Trunk Unit CD Changer Magazine Won't Eject

(Supersedes 92-026, dated October 2, 1992)

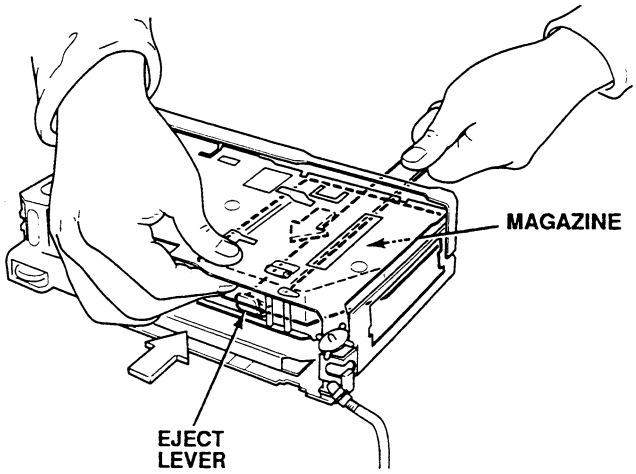
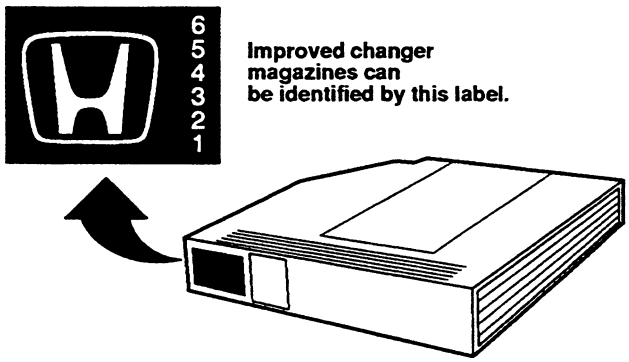
The CD changer magazine will not eject from the changer.

1. Remove the CD changer from the car.
2. Remove the side covers and the top case.
3. Slide a slim jim or a stainless steel ruler between the lower side of the CD magazine and the changer.
4. Push the eject lever toward the back of the unit while pulling the magazine out of the front opening.

Replace the magazine in the changer, and any other Honda magazines the customer may have, with the improved magazine. See PARTS INFORMATION.

5. Reassemble the CD changer.
6. Reinstall the changer in the car.
7. Replace the changer magazine with the new part.
